**Re: PUBLIC COMMENTS:**
"National Emissions Standards for Hazardous Air Pollutants from Coal- and Oil-Fired Electric Utility Steam Generating Units"
Docket ID No.:  EPA-HQ-OAR-2009-0234 (NESHAP/MATS action)

Tekran Instruments Corporation provides, herein, our perspectives on the subject NESHAPS Docket, with particular focus on the proposed tolerances on the Relative Accuracy Test Audits results.

Figure E-5: Sorbent Trap Bias Error With Respect To OHM

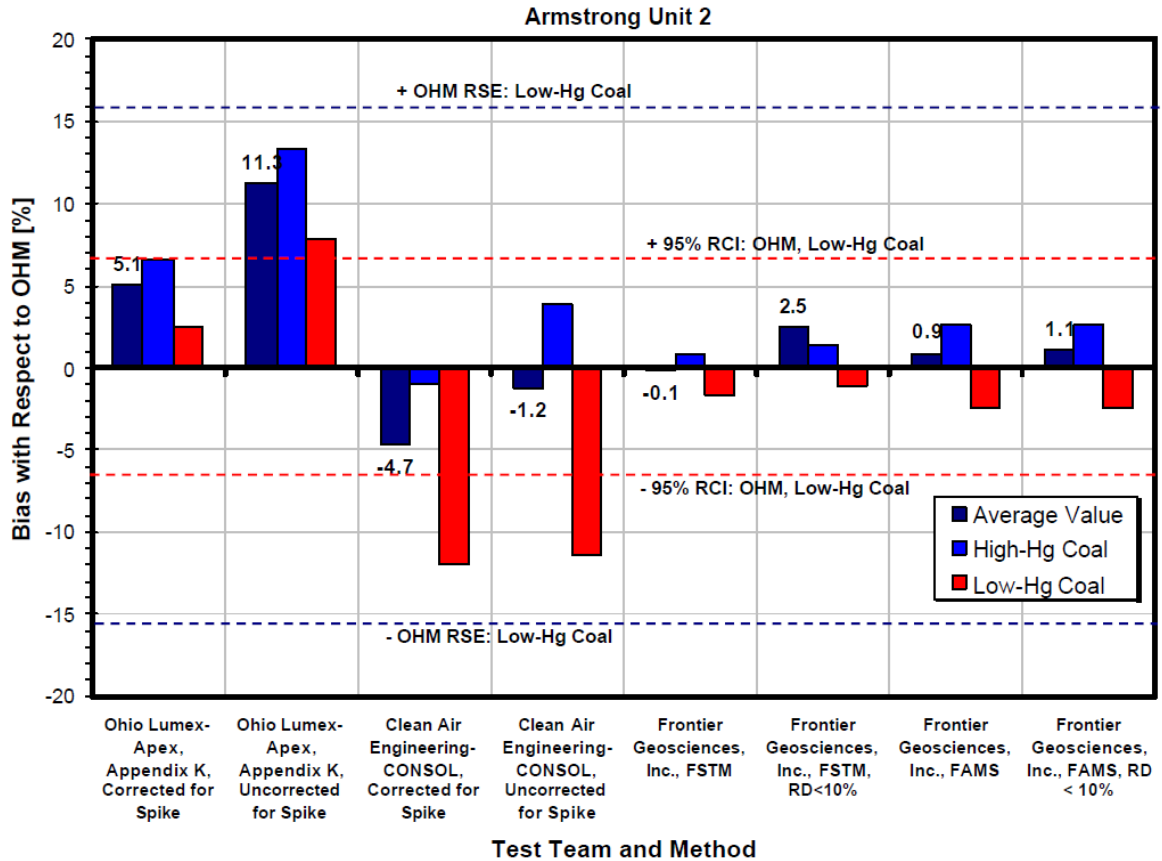
The above Figure was extracted from Reference **[4]**.   Mercury concentrations during the test campaigns ranged from approximately $7 - 27$ µg/m$^3$.   As such, biases of just 1 percent represent significant differences in absolute mercury concentrations.
